November 18, 2021

Re: Objection to erect a new Jetty in Richmond Bay and Quarry operations at Richmond.

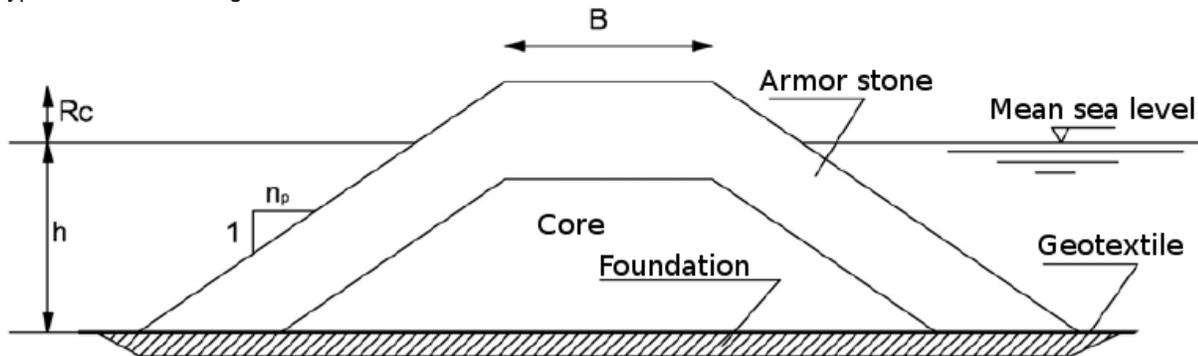
Parameters related to beach and sediment are:

- Depth at tip of groin;
- Beach morphology (slope, berm height, shape of the shoreline etc.);
- Depth at the average breaker line or beach closure;
- Sediment availability;
- Grains size and variability;
- Sediment density.

Typical dimensions of groins.

- h - depth of the basement of the groin head with respect to mean sea level (msl)- From 2.5 to 4 m.
- R_c - height of the groin top with respect to mean sea level - From 0.5 to 1.5 m.
- Depth of the groin basement landward with respect to mean sea level - From 1.0 to 2.0 m.
- B - Width of the groin top - From 3.0 to 6.0 m.
- $1/n_p$ - Slope of the groin sides - From 1:1 to 1:2.
- Thickness of foundation - From 0.5 to 1.0 m.

Stability of groins should be verified against extreme sea conditions. If groins are made by boulders, the stability of the single stone should be checked against the expected wave energy.
